SITE PROBLEM
REPORT TRANSMITTAL

FILE: 13-5-322
CONTRACT NO: 620-00 05
SPR 322 REV. 1
TITLE LOW PRESS.
LEVEL FOLLOWING
REACTOR TRIP
DATE: 6-25-76

SITE PROBLEM REPORT

TITLE LOW PRESSURIZER LEVEL FOLLOWING REACTOR TRIP

FEEDWATER PUMP SPEED "RICKER" MODIFICATION TO THE ICS

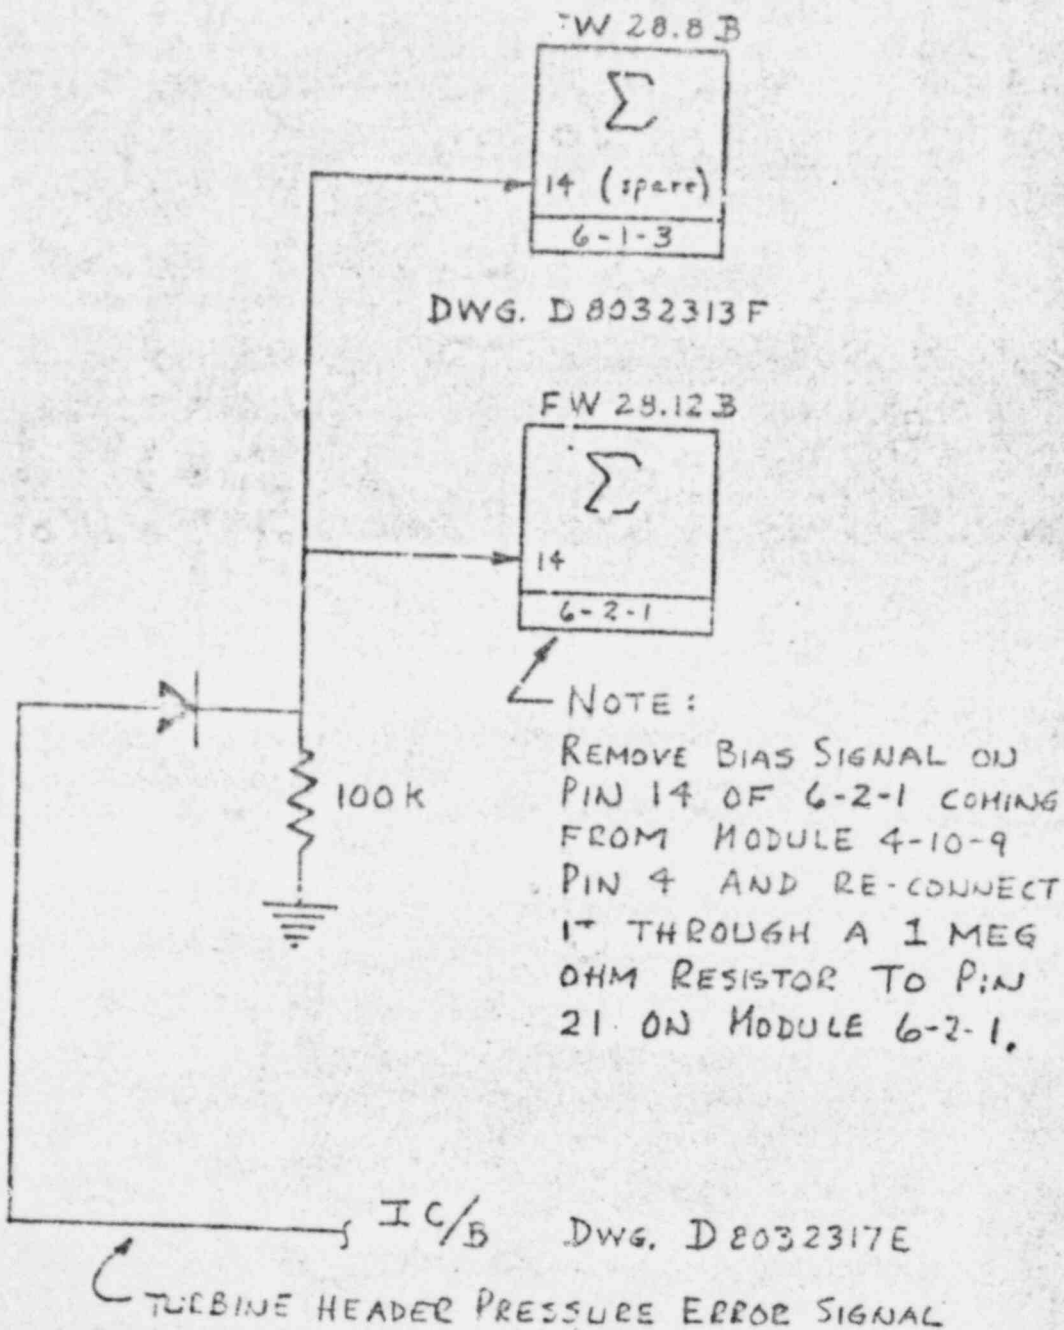
The following information on a modified Feedwater Pump Speed Control Circuit, which has been implemented at the TMI-1 Plant, is being forwarded at this time to allow incorporation prior to any additional load rejection tests scheduled for Units 1, 2, or 3. B&W recommends this as a temporary change to your ICS which will be followed up by a field change package.

The purpose of the Pump Speed "Kicker" Circuit is to enable the feedwater flow control system to continue to deliver a high level of flow to each Steam Generator, even though the steam outlet pressure has suddenly increased approximately 150 psi. The modification originated and implemented at TMI-1 improved the overall plant performance by directly increasing feedwater pump speed more rapidly than could be accomplished by the combined action of the feedwater control valve and pump speed controllers in the ICS.

The modification to the present Unit #1 ICS is the following:

Route an additional wire from the turbine header pressure error signal (IC/B on Drawing Unit #1) to two summers which are shown on Drawing D80J2311F. The particular summers are FW28.8B(6-1-3) and FW28.12B(6-2-1) and the new signal is to be connected to each summer. In the new line also install a diode and a 100 k ohm resistor in a path to ground. Refer to the attached schematic.

The turbine header pressure control error signal has the following effective range:

- + 10 Volts = 300 psi above setpoint.
- + 0.5 Volts = 15 psi above setpoint.
- Any signal below 0.5 Volts will be blocked by the diode in the new line.

The gain for the turbine header pressure error signal on each summer will have to be calculated and set by Duke Power Company. The calculation used at TMI-1 is given below:

OPTION 1
TURBINE BYPASS VALVE CONTROL

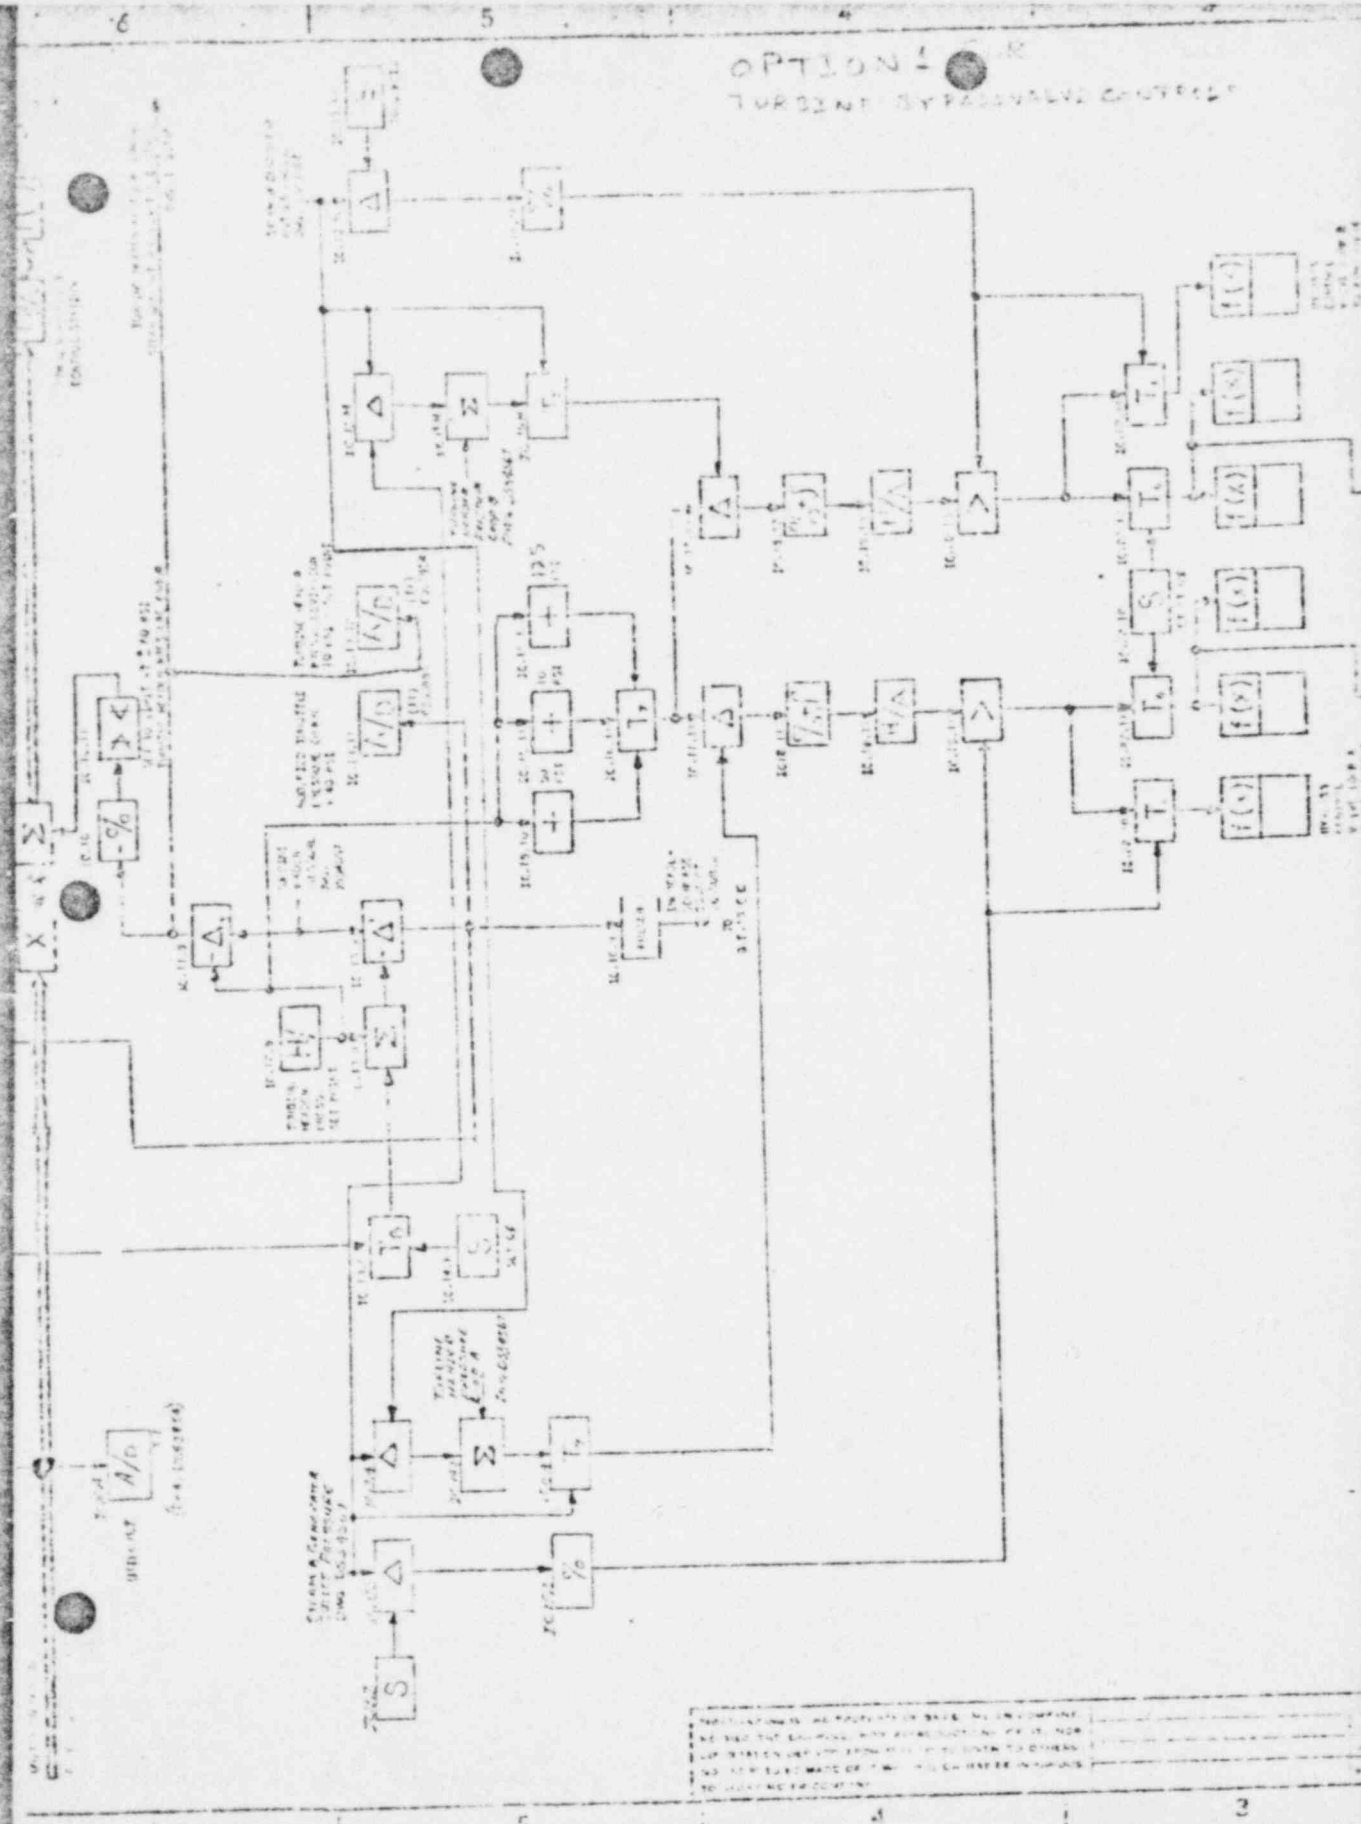
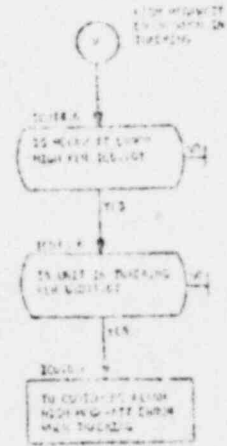
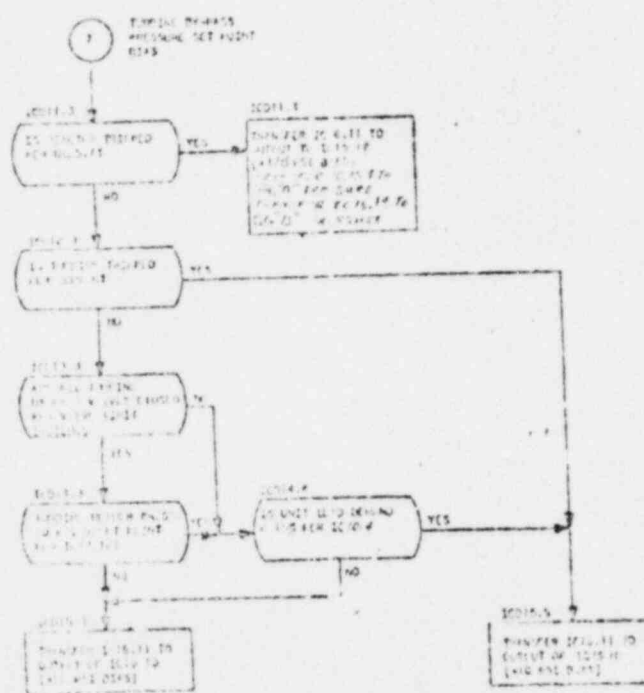
The fact that the Turbine Header pressure remains higher for a time holds the Turbine Bypass Valves open longer than necessary. (AFTER The Safety Valves have closed)

It is believed that this area could be improved by having the turbine bypass valves modulate to control Steam Generator pressure when the reactor is tripped instead of turbine header pressure. Getting these valves closed sooner after a trip should keep the Steam generator pressure from dropping so low which would keep the steam generator temperature higher and therefore TAVE. This should then keep the pressurizer level from dropping so low because it would not have to make up as much volume in the RC system.

Alternate TB control
using STM Gen. PR455,
Drawn at BRW6X054257

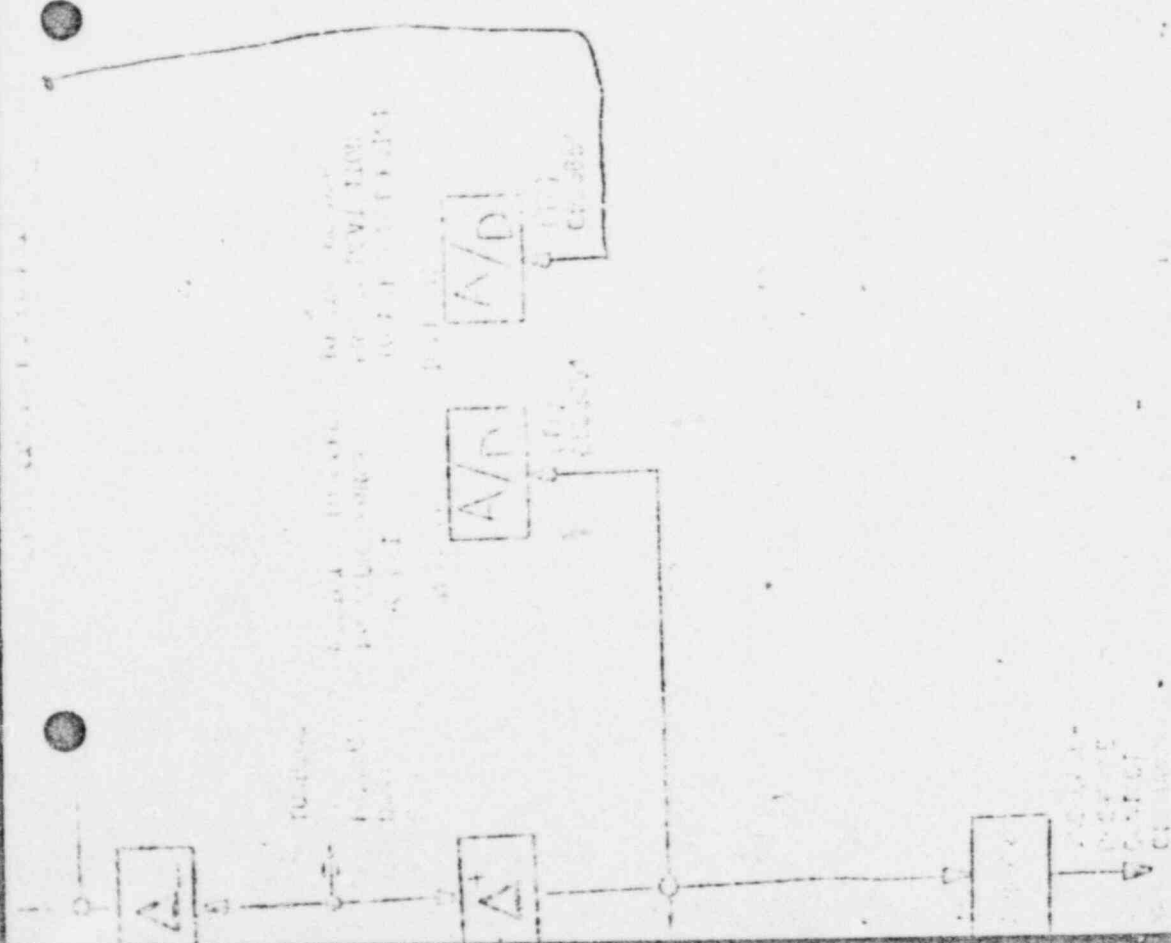
The attached logic and schematic drawings reflect a suggested way to utilize the atmospheric relief valves to open for overpressure at any time, whether the turbine bypass valves are available or not.
